RAI 3.6.2.2.2-1a (High Voltage Insulators)

LRA 3.6.2.2.2 Degradation of Insulator Quality due to Presence of Any Salt Deposits and Surface Contamination, and Loss of Material due to Mechanical Wear

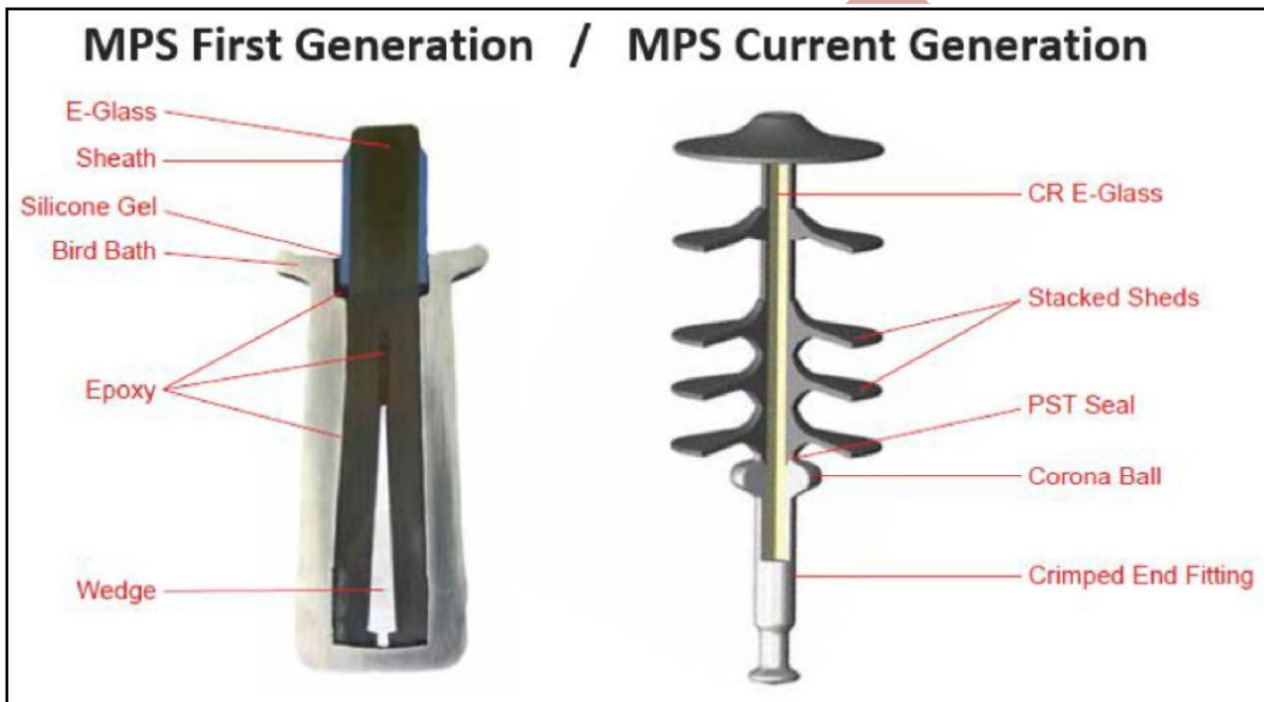
1. Explain why epoxy, silicone gel, sealants, and ductile iron are not listed in the response to RAI 3.6.2.2.2-1 as materials that are used in construction of polymer high-voltage insulators.

Information from the manufacturer (MacLean Power Systems or MPS) of the RBS polymer insulators does not discuss "ductile iron" for the corona ring or the end fittings, which are the only metal components on the insulators. The connection hardware does include ductile iron.

The response to RAI 3.6.2.2-1 stated, “The RBS polymer high-voltage insulators and connection hardware have the following materials: fiberglass, silicone rubber, aluminum and aluminum alloy, steel and steel alloys, galvanized metal (galvanized ductile iron, galvanized forged steel, steel hot dip galvanized).” Therefore, galvanized ductile iron is explicitly identified.

The RBS polymer high-voltage insulators are a recent generation of MPS polymer insulators that have been manufactured since 2007. The RBS polymer insulators do not use epoxy. The following figure shows the difference between the first generation of MPS polymer insulators and the generation of MPS polymer insulators that are used at RBS.

The MPS polymer insulators in service at RBS use a PST sealing system, which is a triple seal design. The triple seal or PST seal comprises the primary seal (P), the secondary seal (S), and the tertiary seal (T). The primary seal is a silicone rubber sheath compressed into the chamfer of the crimped end fitting. The secondary seal is RTV (room temperature vulcanizing) silicone applied to the rod, sheath, and end fitting interface. The tertiary seal is a final external RTV silicone seal applied to the sheath and end fitting interface. The RBS polymer insulators do not utilize silicone gel. The response to RAI 3.6.2.2-1 included silicone rubber, but did not explicitly identify RTV silicone as a type of silicone rubber. The silicone rubber material includes the RTV silicone that is part of the PST seal system. The RBS polymer insulators do not include silicone gel or sealants other than RTV silicone.
